STAFF REPORT: MARCH 13, 2024 MEETING

APPLICATION NUMBER: HDC2024-00038

ADDRESS: 2905 GARLAND (AKA THE OSSIAN SWEET HOUSE)

SCOPE: INSTALLATION OF SECURITY CAMERAS

Applicant diagram. Red identifies range of interior cameras. Green identifies range of front and rear entrance cameras. Blue identifies range of side wall cameras.

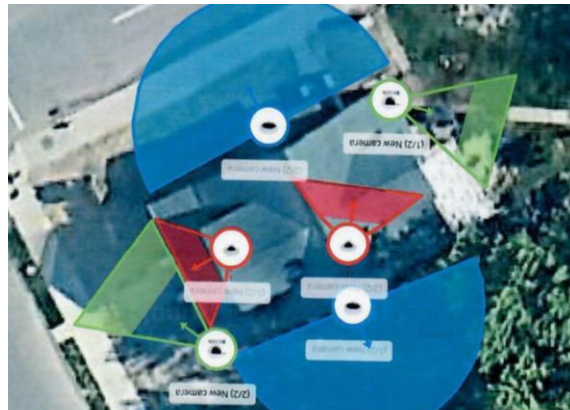
- It is staff’s opinion that the installation of cameras as proposed does not meet the Commission’s guidelines (guidelines define work that can be reviewed/approved at a staff level) nor the Secretary of the Interior’s Standards.

- As stated earlier in this report, it is staff’s opinion that each side of the dwelling is historically and architecturally significant and is considered a distinctive character-defining feature.
 - The four cameras are to be located in visually prominent locations and will severely alter the features and spaces that characterize the property.
 - Three of the four cameras are proposed to be installed on masonry walls. It is not clear if the mounting hardware can be placed within mortar joints (regardless of where on a masonry wall the camera is proposed). Mounting on the brick would permanently damage a significant architectural feature.
 - Different cameras may be available within the marketplace that can be installed within the eaves.

Staff therefore recommends that the Commission issue a Denial for the work as proposed, as it does not meet the Secretary of the Interior's Standards for Rehabilitation, specifically Standards 1, 2, and 9:
